**Frequency Response and Frequency Bias            )     Docket No. RM13-11-000**  
**Setting Reliability Standard                         )     )**

**COMMENTS OF THE  
NORTH AMERICAN ELECTRIC RELIABILITY CORPORATION  
IN RESPONSE TO NOTICE OF PROPOSED RULEMAKING**

**COMMENTS OF THE  
NORTH AMERICAN ELECTRIC RELIABILITY CORPORATION  
IN RESPONSE TO NOTICE OF PROPOSED RULEMAKING**

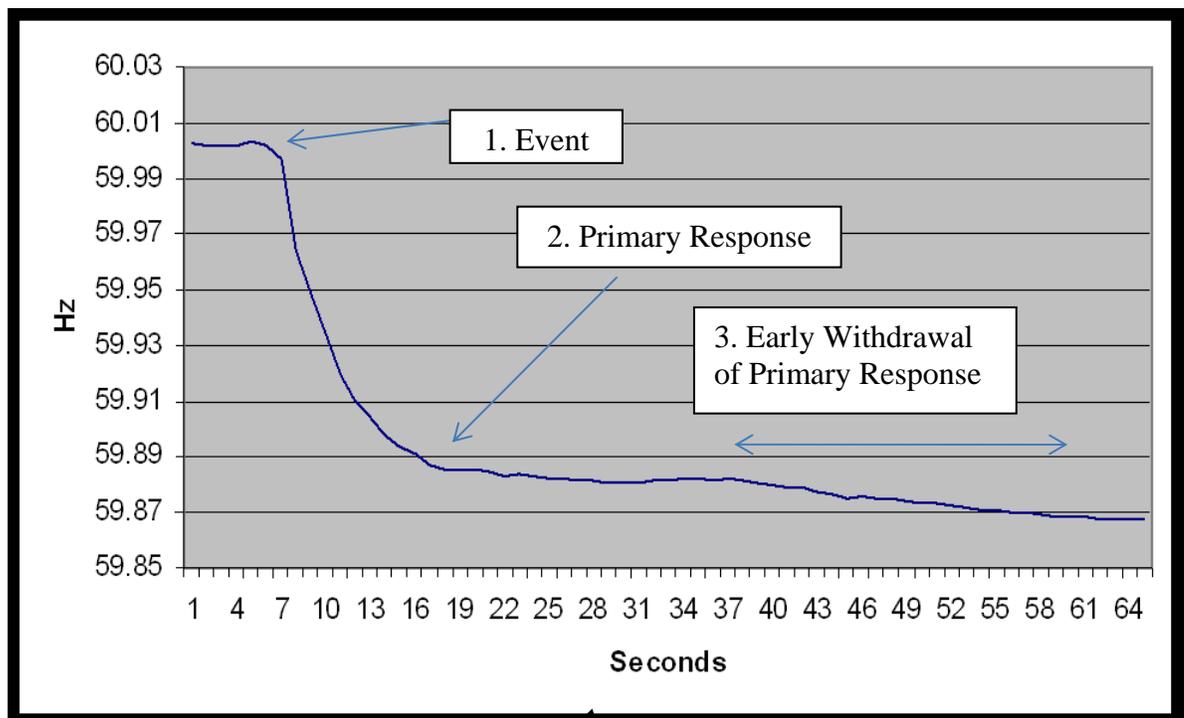
Following the sudden loss of generation, the automatic and immediate increase in power output by resources providing primary frequency control seeks to quickly arrest and stabilize the frequency of the Interconnection, usually within 30 seconds or less. AGC typically provides most of its secondary Frequency Response to return frequency to the scheduled value in time frames longer than one minute after the loss of generation. If a significant amount of primary Frequency Response is withdrawn before the secondary Frequency Response is activated, a further drop in Frequency Response will occur. The Commission illustrated this drop in frequency in the following diagram in the NOPR:<sup>16</sup>

As the standard drafting team noted, the issue of premature withdrawal of Frequency Response is a potential concern. However, the standard drafting team accounted for this issue in

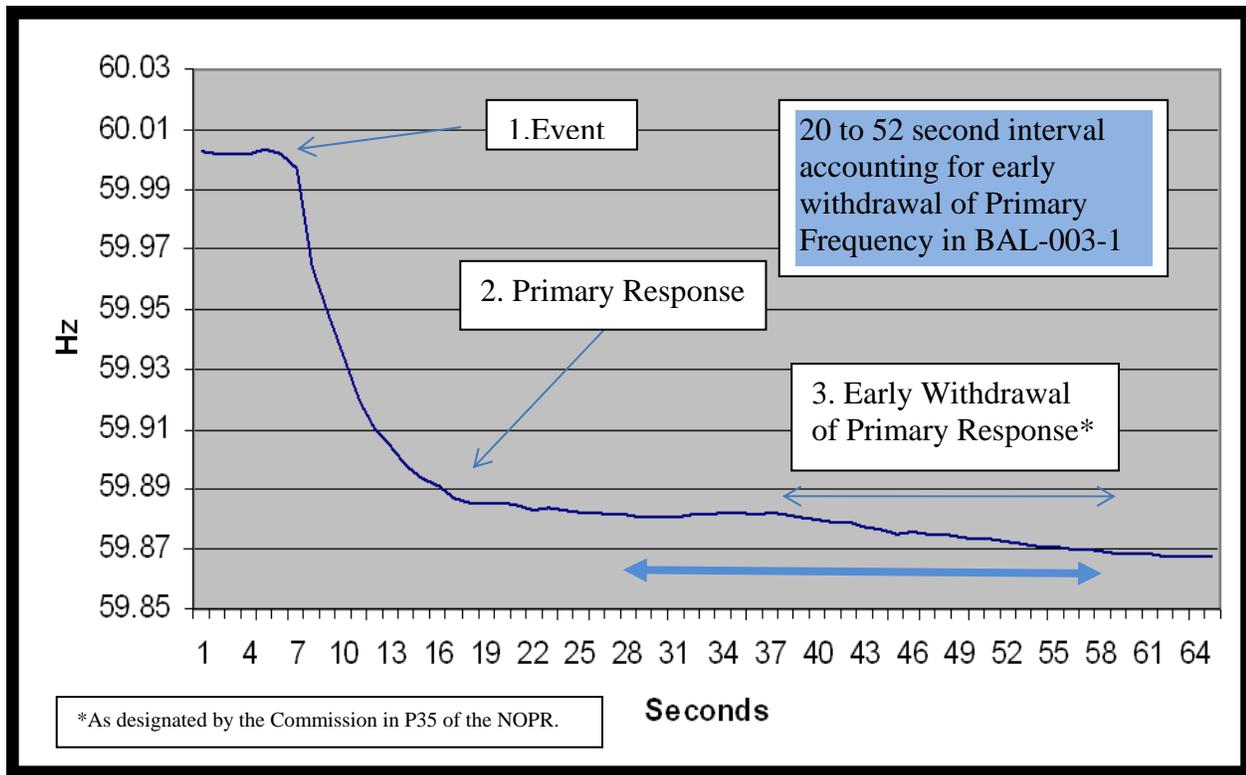
The effect of this 20 to 52 second interval is that if there is withdrawal during that period, the metric will have a lower value, which will then lower an entity's median score thereby impacting compliance with Requirement R1 of proposed Reliability Standard BAL-003-1.<sup>19</sup> As demonstrated in the diagram below, the standard drafting team has accounted for an interval of time (20 to 52 seconds) that precedes the interval identified by the Commission (approximately 38 to 60 seconds) and is ten seconds longer in overall duration.
